City Council
Agenda Supplement

Meeting Date: May 7, 2024

Item: REPORT OF THE PLANNING & ZONING COMMISSION

Miles Diamond, petitioner
142 Edgewood Avenue

ELEVATION PLAN FOR NEW GARAGE

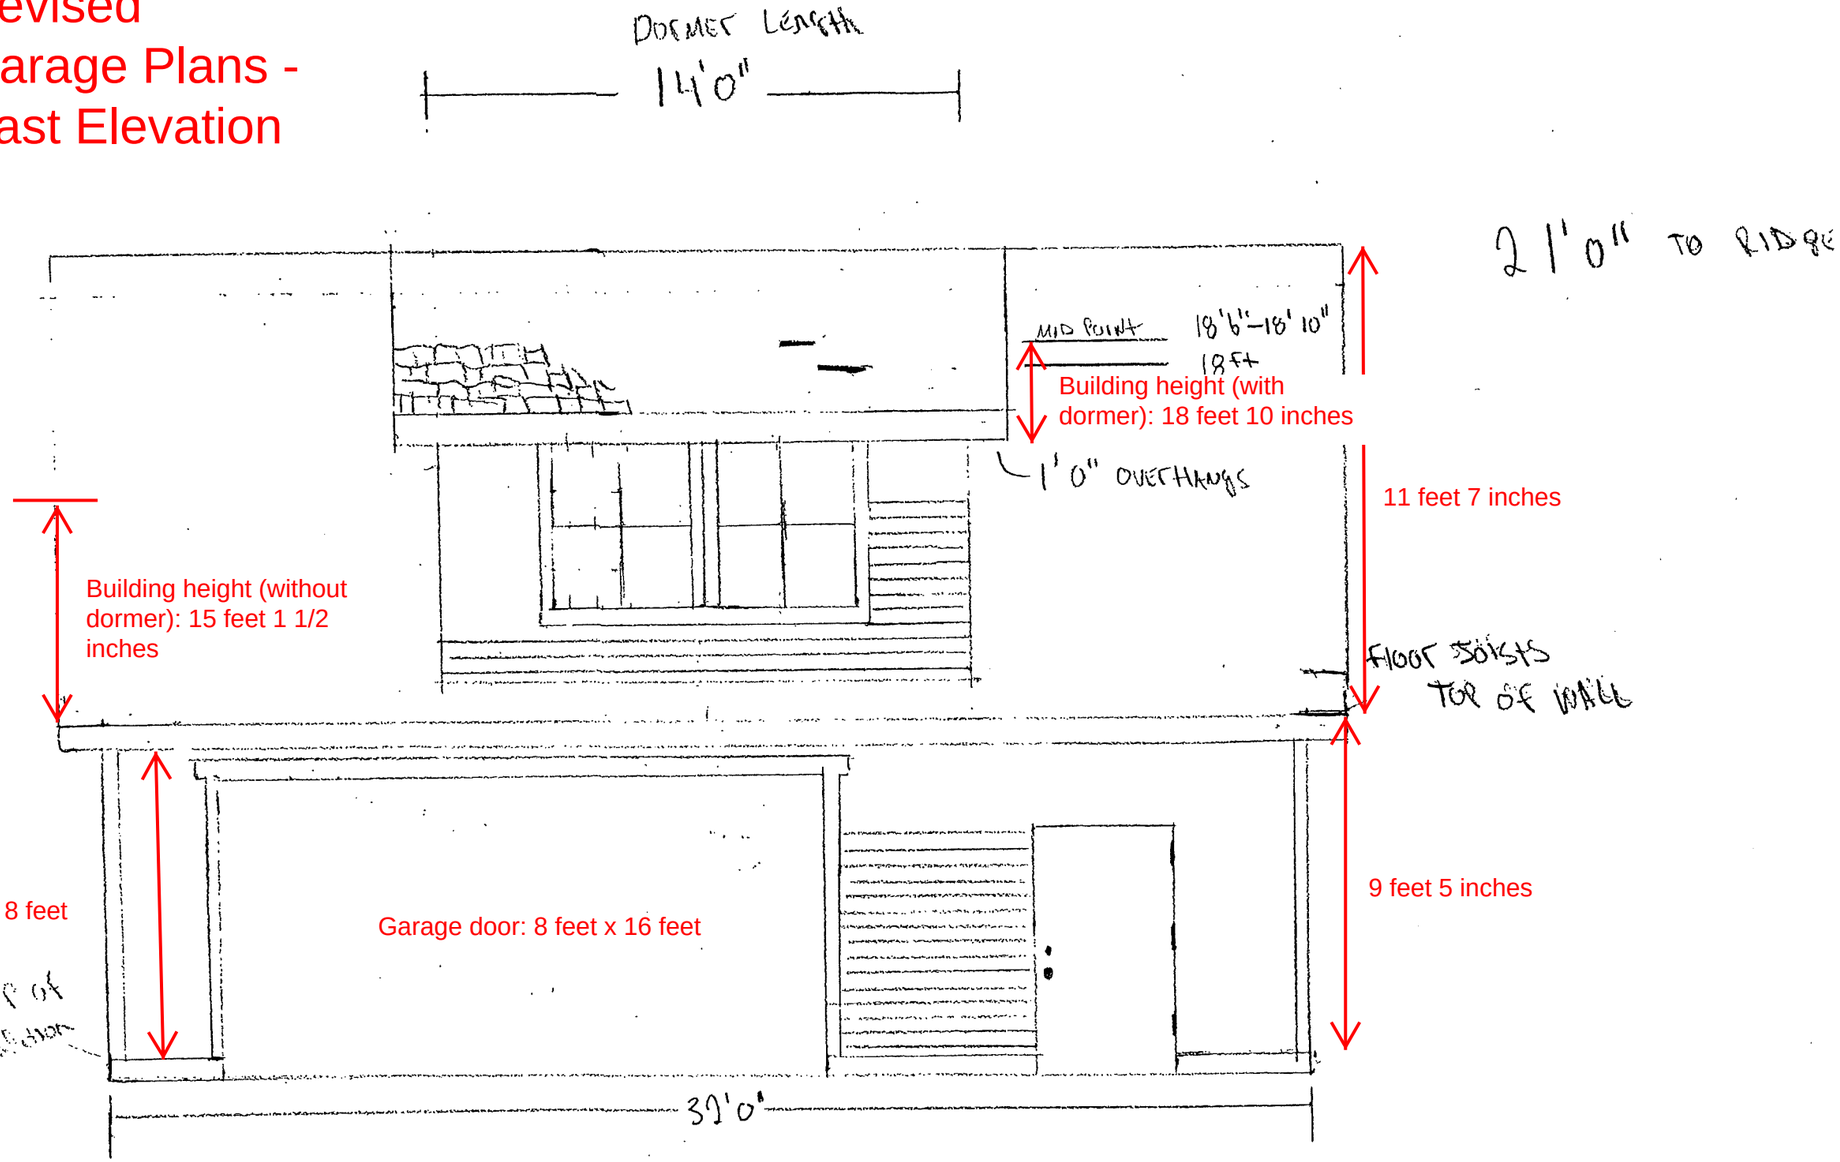
- The building height of the garage is 18 feet 10 inches, which exceeds the maximum allowable 18 feet for accessory structures. This is a variation of 10 inches.

- Accessory structures are limited to a single dormer per side elevation, which can be no wider than 20% of the length of each side elevation. The garage would have two (2) dormers, one (1) on the east elevation (front) and one (1) the west elevation (rear). The maximum permitted length per elevation is 6 feet 4 inches. The petitioner is proposing each dormer at 14 feet in width (67%), which is a variation of 7 feet 6 inches per elevation.

- Based on the size of the dormer, staff has determined the dormer roofline shall be used to determine the building height. Thus, the building height from the dormer roofline is 18 feet 10 inches, which exceeds the UDO requirements by 10 inches. Without the dormer, the height of the garage would in conformance with the UDO, as the building height of the garage roofline would be at 15 feet 1 ½ inches.

Mr. Skluzacek stated he is ok with the five (5) foot setback but would like to see only one (1) dormer and is not ok with the height. Mr. Dan Diamond spoke to the standard garage size and the constructions details of the garage. They cannot bring down the height, or they would have to change the design.

The Planning and Zoning Commission recommended **denial (6-0) of the height and dormer length variations and approval (6-0) of the setback variation**.

3. The height of the garage shall be reduced to 18 feet. 21'-5"+-

BUILDING ELEVATIONS

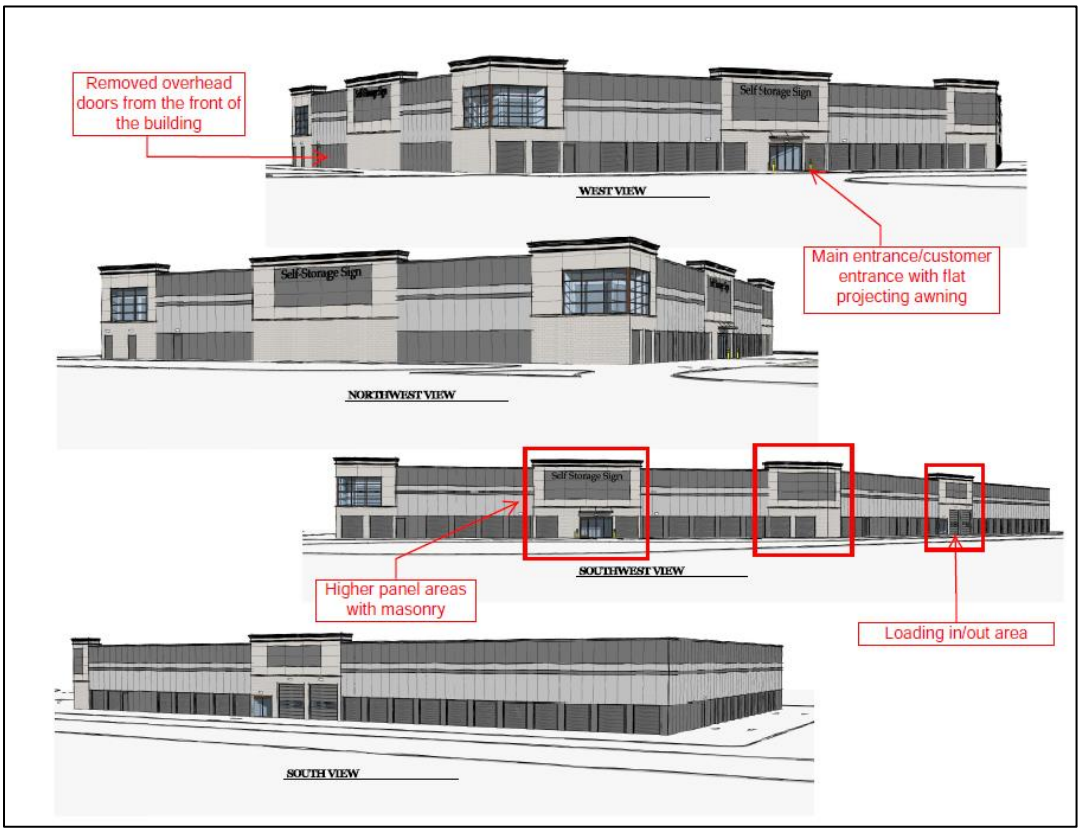
- The building height was reduced from 42 feet and three (3) stories to 29 feet and two (2) stories, which now meets the UDO requirements.
- The proposed building will include a combination of light and dark grey metal panels and smooth insulated panels and masonry.

- There are 62 units on the first floor with overhead doors.
- Industrial developments are required to comply with at least three (3) of the optional design standards. The proposed building meets (one) 1 of the six (6) design standards.

2. Elevations:
   A. Work with staff on ways to further enhance the elevations, such as, walls offsets and faux windows to break up the long wall expanses.
   B. Further reduce the number of exterior doors to allow for some foundation landscaping.
   C. Provide decorative exterior doors to provide variation.
   D. Increase the masonry around the base of the building.
